COMMUNITY AFFAIRS

Residential Site Improvement Standards

Streets and Parking; Stormwater Management

Proposed Amendments: N.J.A.C. 5:21-4.1, Table 4.1; 5:21-4.2, Table 4.3; 5:21-4.19, Table 4.8 and Figures 4.2 through 4.5; 5:21-7.2, 7.3 and 8.1

Source: NRCS, NJ Supplement, Dimensionless Unit Hydrograph, September 2003.

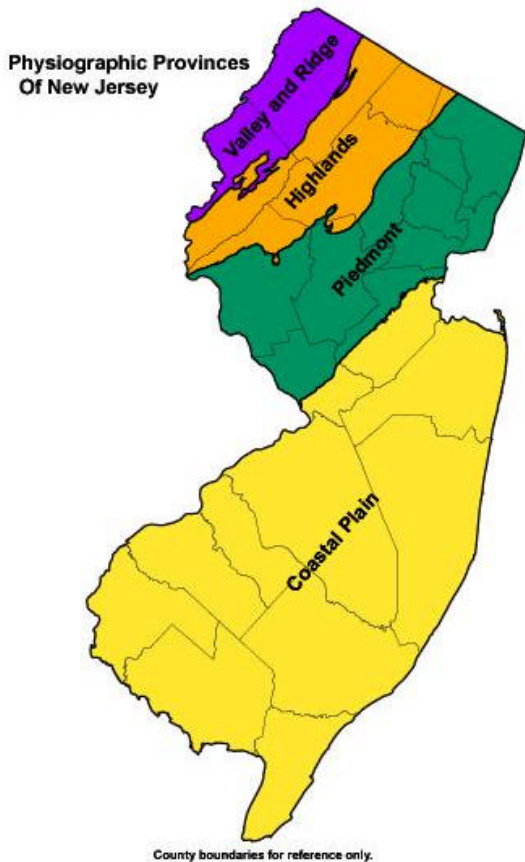
4. 5:21-7.2(c) 1.vi. - The proposed amendments add references to United States Department of Agriculture (USDA), Natural Resources Conservation Service (NRCS) bulletins for the use of the most recent rainfall data available and for the use of the Delmarva unit hydrograph, where appropriate, for preparation of runoff calculations. A map is proposed for addition to show the coastal plain region for use of the Delmarva hydrograph.

vi. Runoff calculations derived from NRCS methods (TR-20 and TR-55) shall be done in accordance with NRCS New Jersey Bulletin No. NJ210-3-1, September 8, 2003 (application of the Delmarva unit hydrograph in the coastal plain region of New Jersey) and NRCS New Jersey Bulletin No. NJ210-4-1, September 8, 2004 (average county rainfall data). The coastal plain region is shown on the map below. New Jersey Bulletin No. NJ210-3-1 from the NRCS calls for the use of the Delmarva hydrograph only in coastal plain areas that have a flat topography (average watershed slope less than 5 percent), low relief, and significant surface storage in swales and depressions. (For more information on NRCS methods in New Jersey see: www.nj.nrcs.usda.gov/.)
